APPLICATION FOR SPECIAL USE PERMIT

Name of Application: 1181 North Avenue

**APPLICATION FOR SPECIAL PERMIT, SITE PLAN AND SUBDIVISION
APPROVAL FOR 1181 NORTH AVENUE**

The owner of 1181 North Avenue is proposing to subdivide an existing 0.74± acre parcel into 2 lots. Our office has reviewed the application, Full EAF, and the following plans entitled "Office Building – 1181 North Avenue" submitted for the project as prepared by Aryeh Siegel, Architect; Hudson Land Design; and John Post, Jr., Land Surveyor:

Sheet 1 of 1 - Preliminary Subdivision Plat

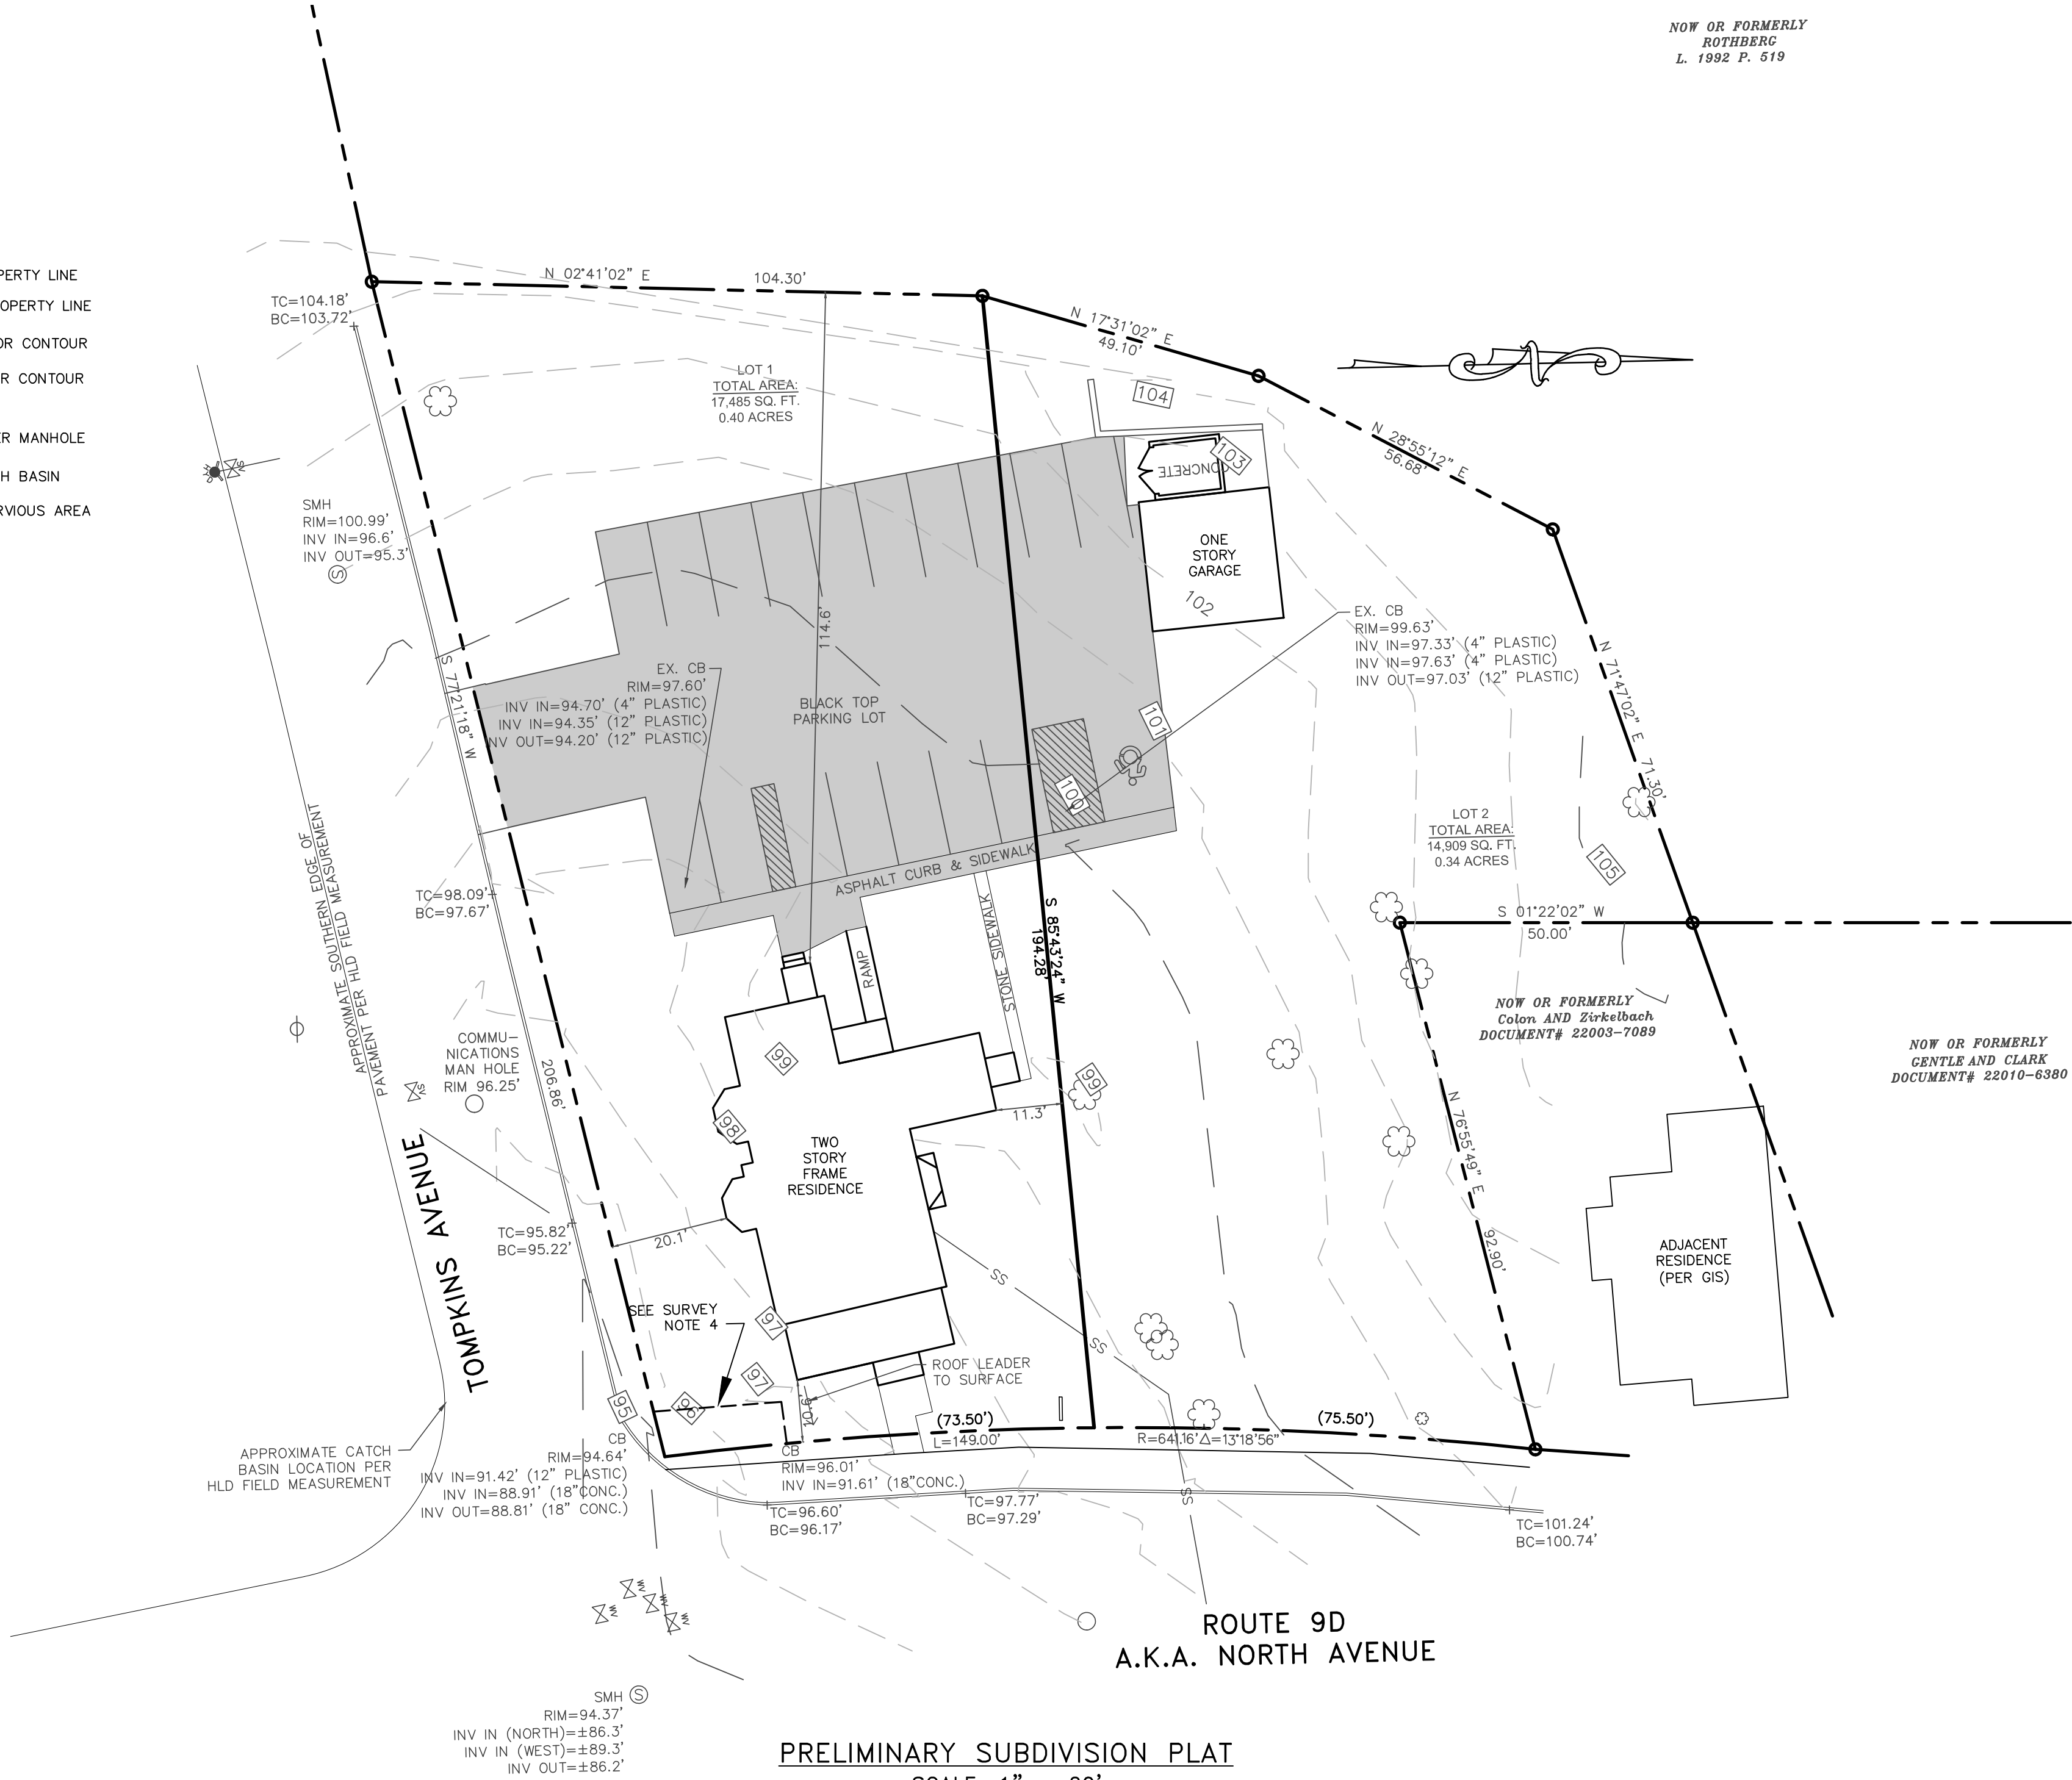
1. The Subdivision Plat should identify major trees over 8 inches diameter and include species.
2. The proposed building is located on a front section of Lot 2 that does not meet the minimum 75-foot lot width standard in Section 223-12 H. The applicant will request an area variance once the SEQR determination has been completed. The Board should issue a recommendation to the ZBA.

Special Use Permit Application
Sheet 4 of 5 - Grading & Utility Plan

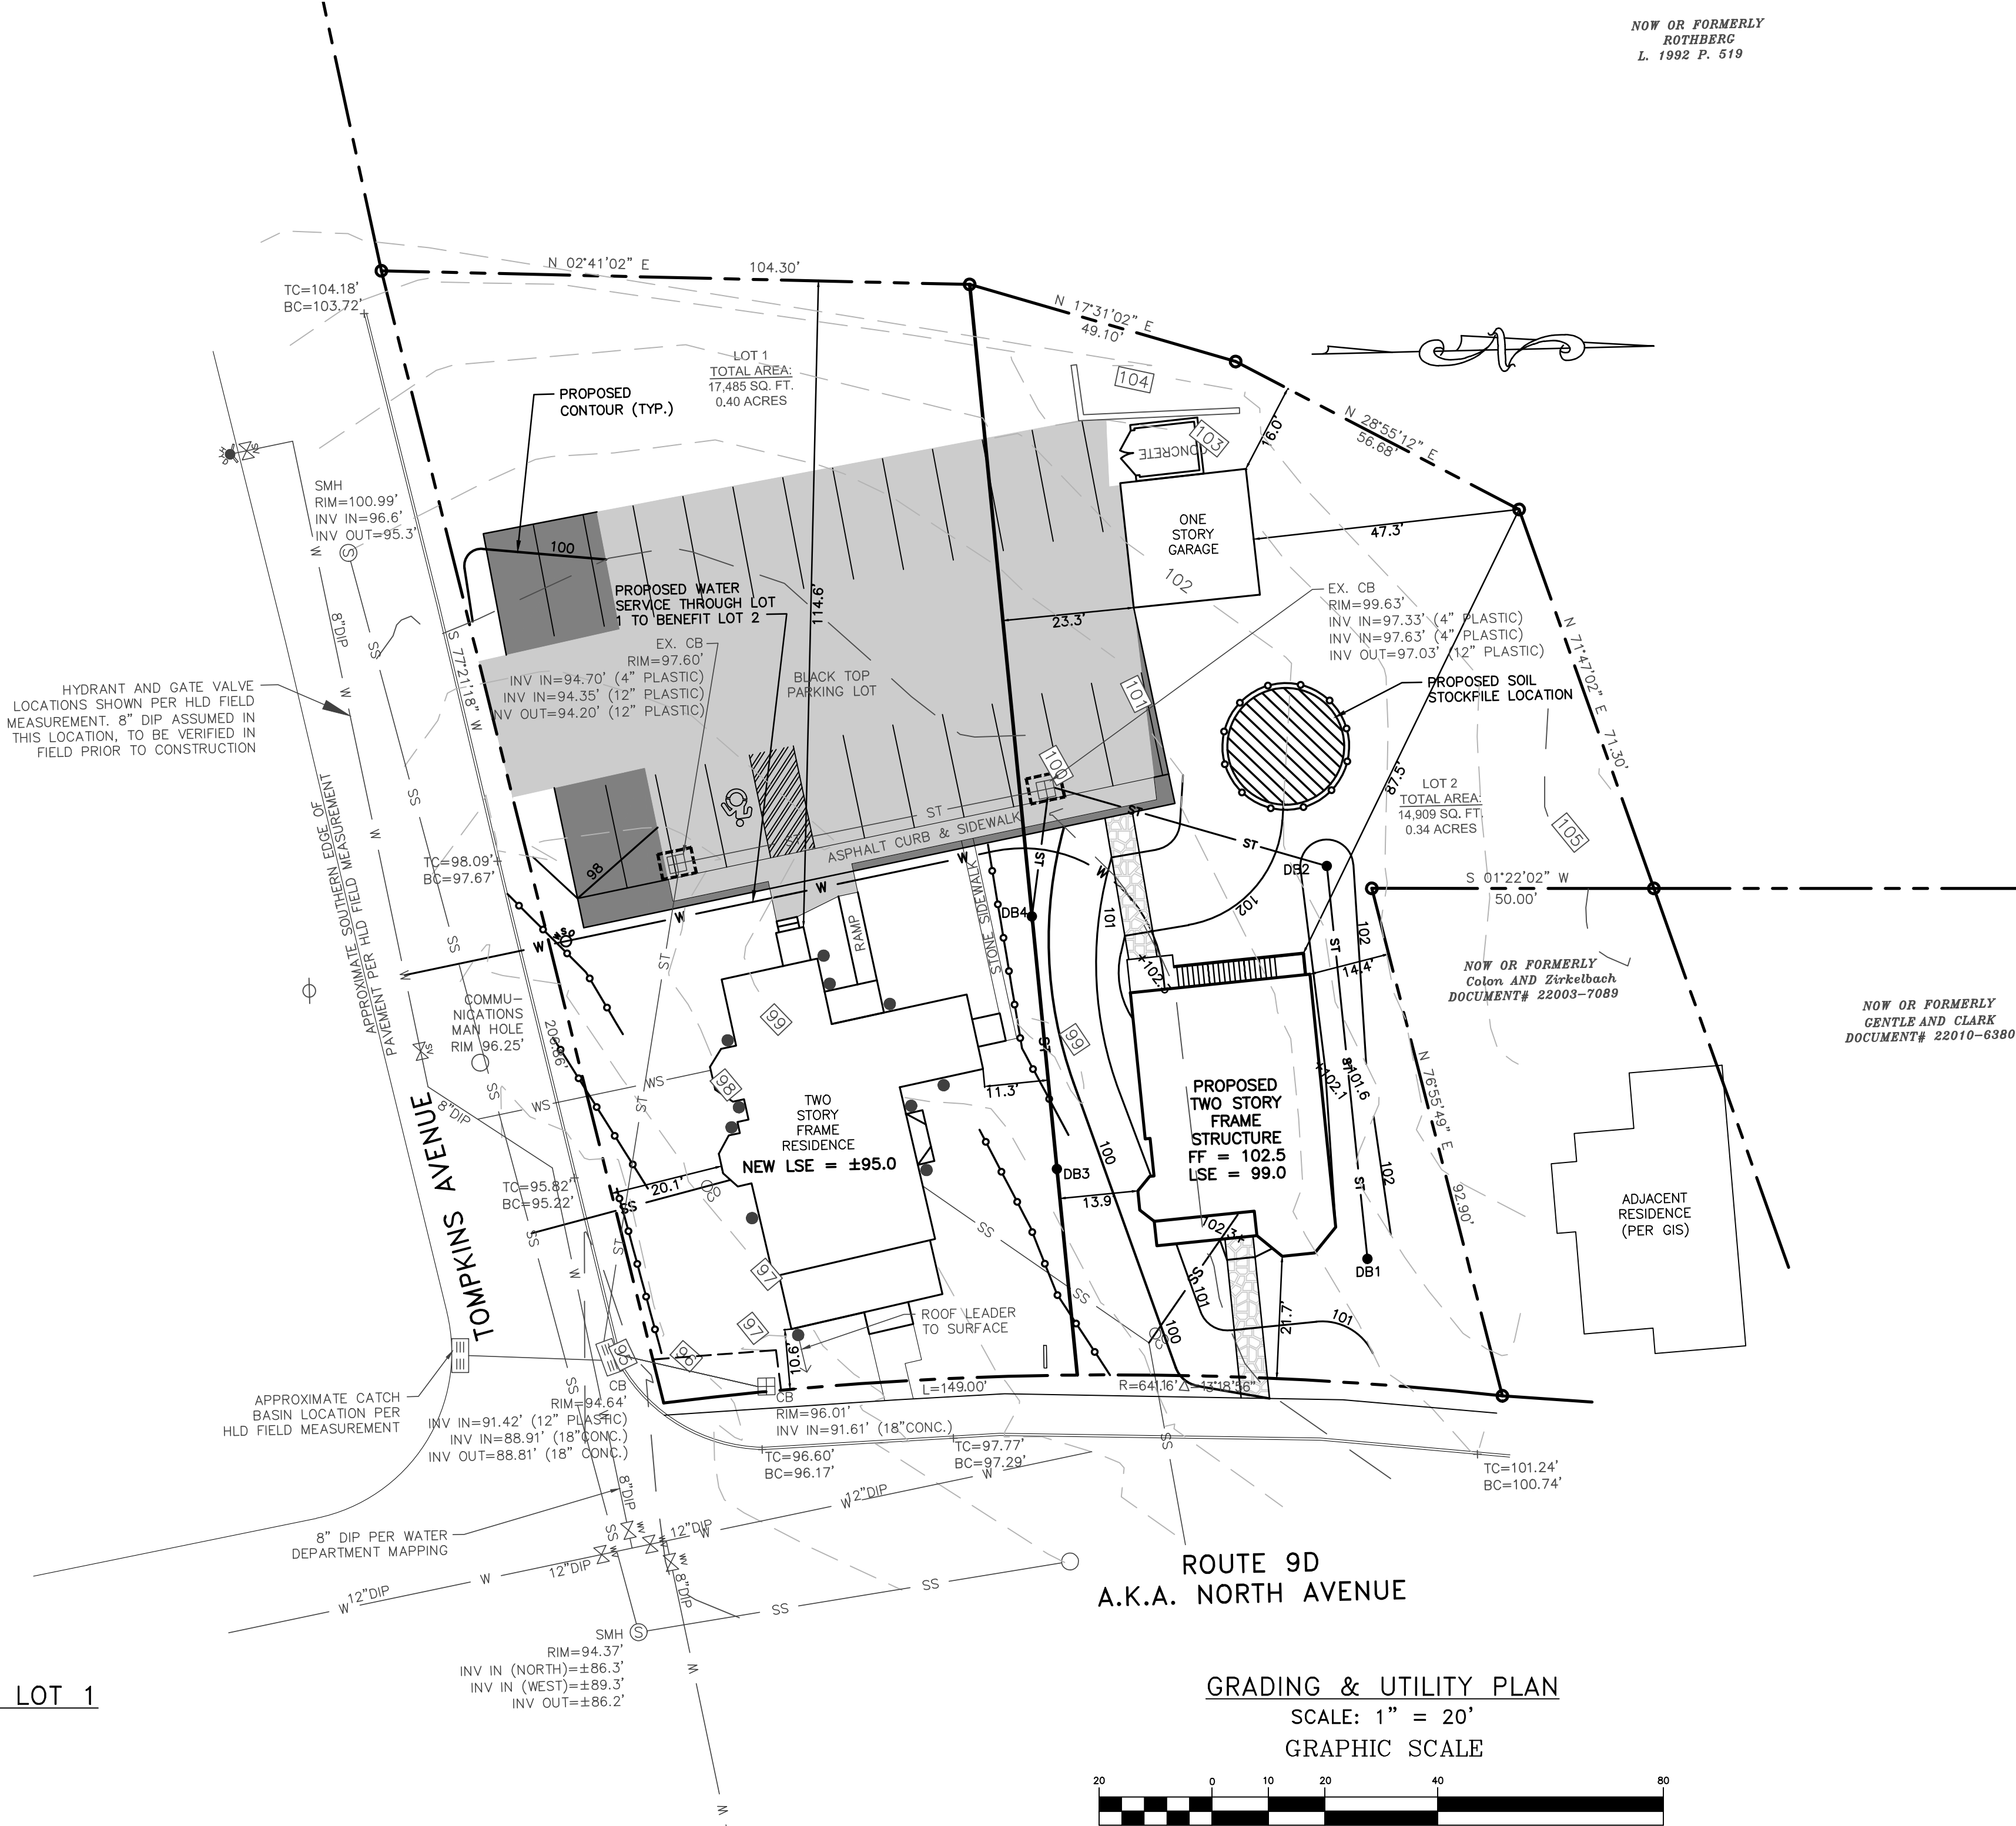
Grading & Utility Plan (Sheet 4 of 5):

1. As previously noted, drainage basins 3 and 4, and the associated piping for these structures are being installed along the proposed common property line between both lots. This will require an easement and maintenance agreement between the lots for access and maintenance of these structures and the related piping. A copy of the easement and maintenance agreement shall be submitted to the Planning Board Attorney for review.
